IMG_1704
Taken by: TBM - HNTB @ 11:17 AM on 1/08/19
Design #1617 - Ramp D over Mississippi Blvd.
Location: first splice from south end on west side
Looking SW

NOTE: throughout this document, suggested issues to be addressed / repaired are book ended with *'s as such *xxx xxx xxx*

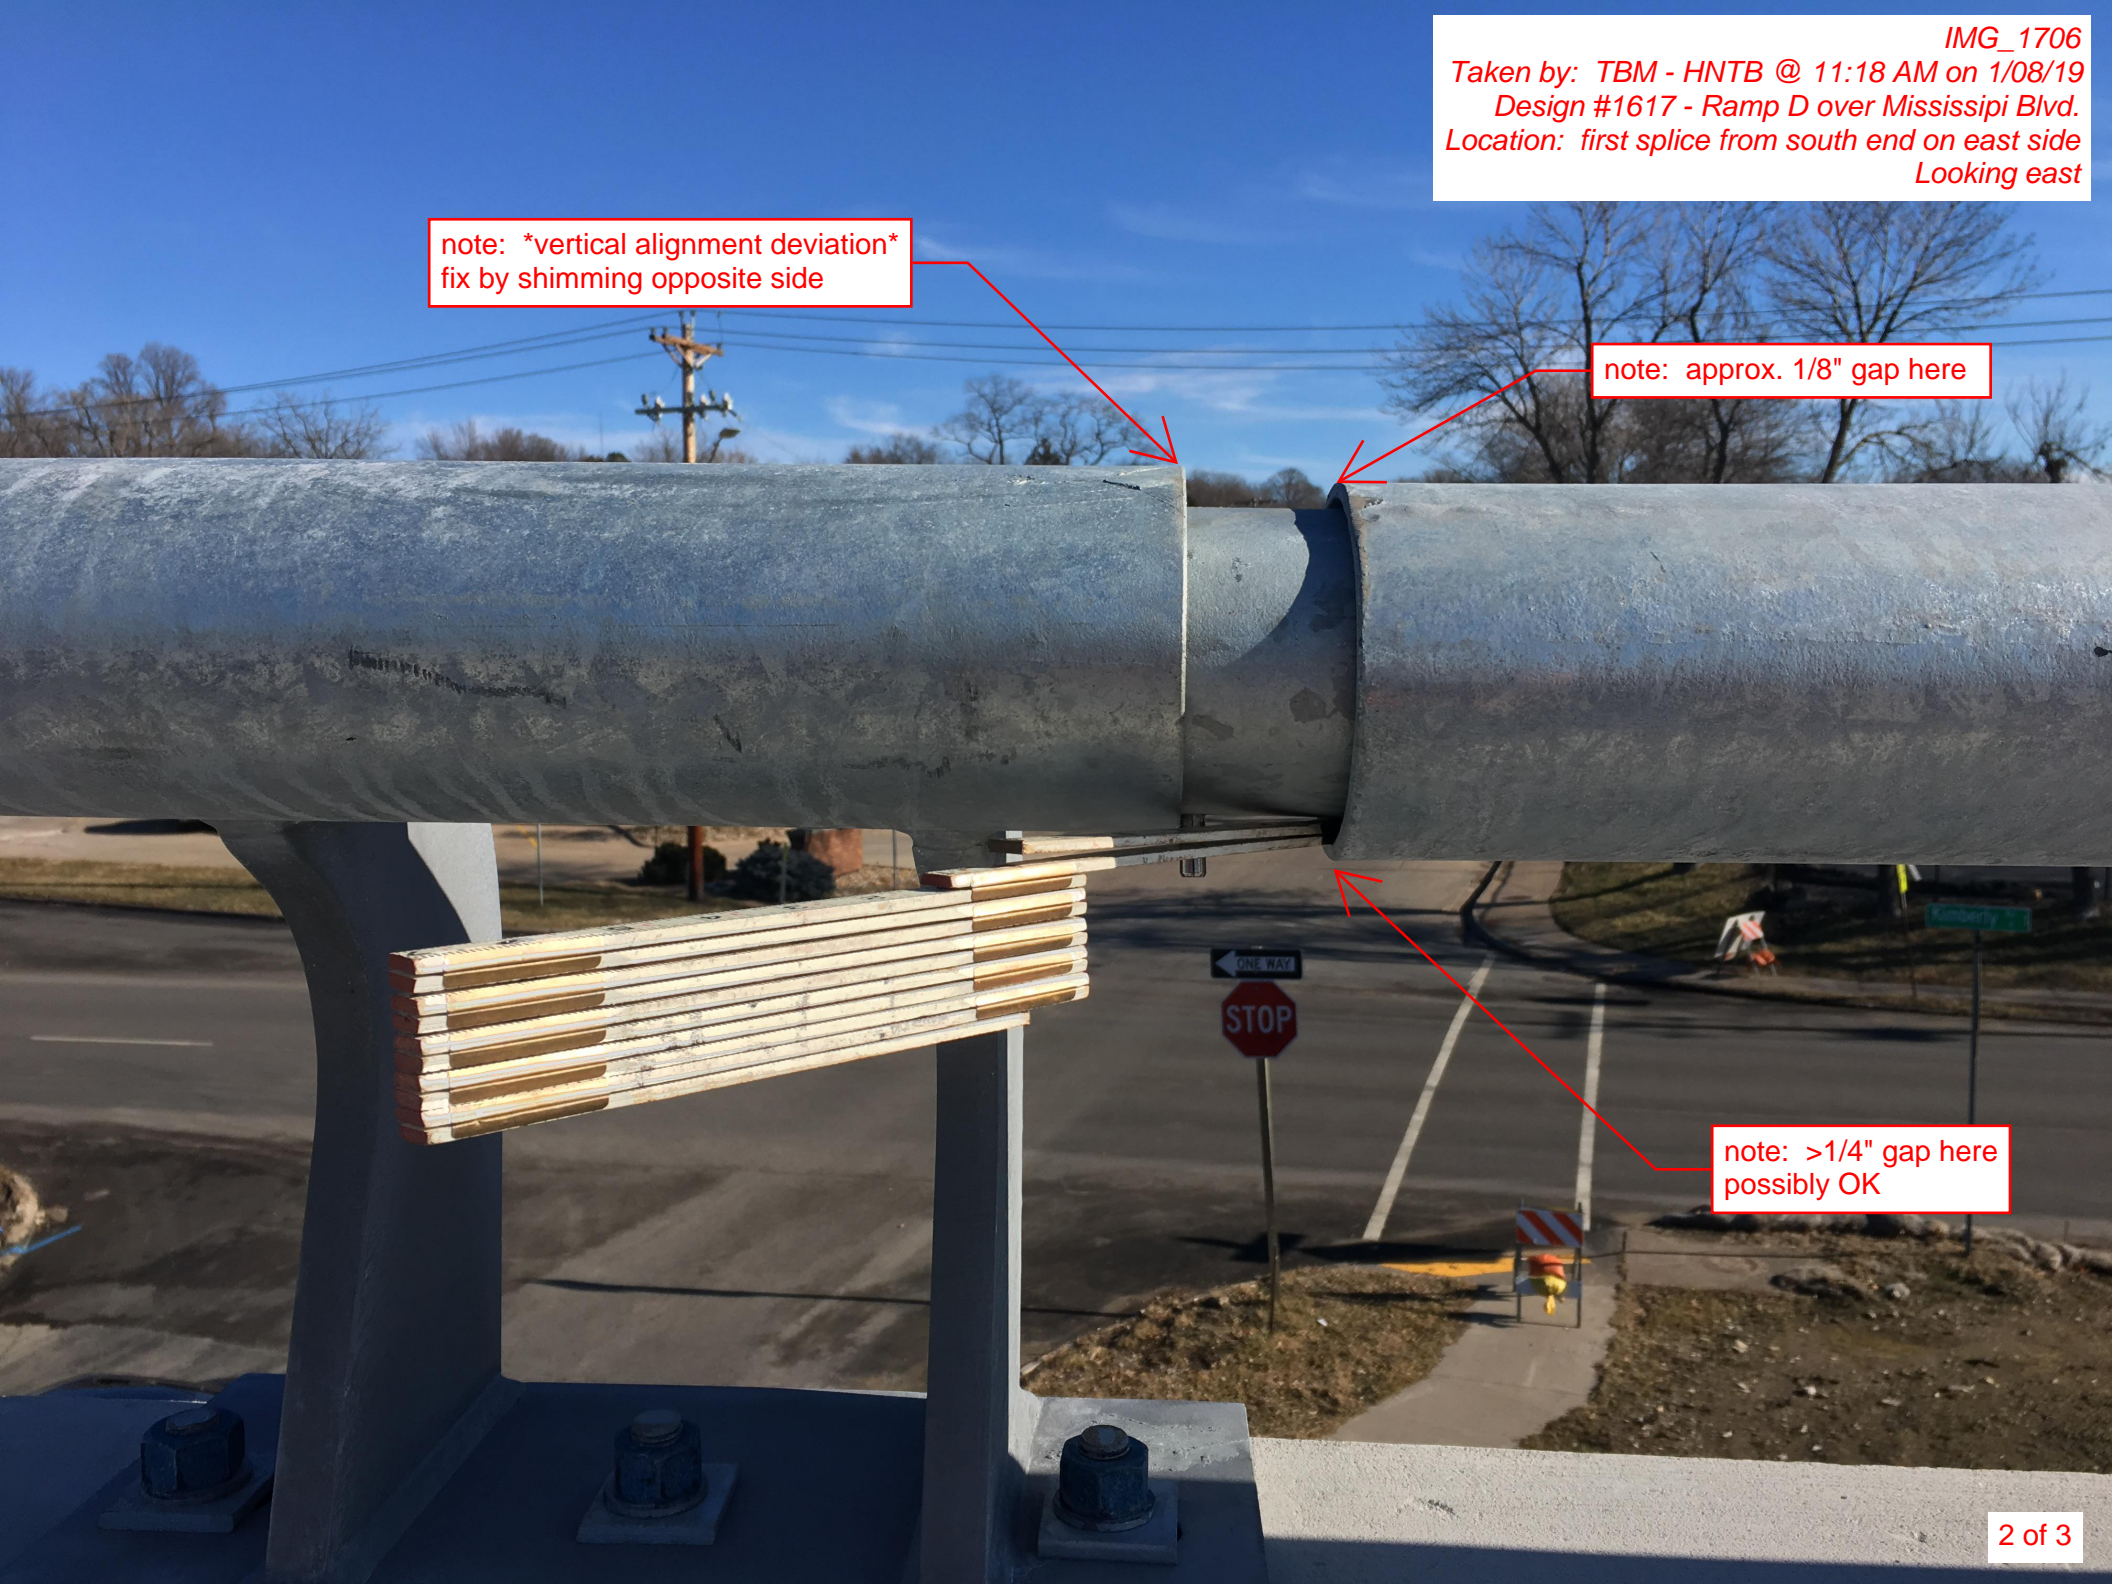
note: large gap here
note: total vertical gap = 7/16"

note: *vertical alignment deviation*
fix by shimming this side

note: tight fit here
note: *galvanizing is already flaking off*
repair
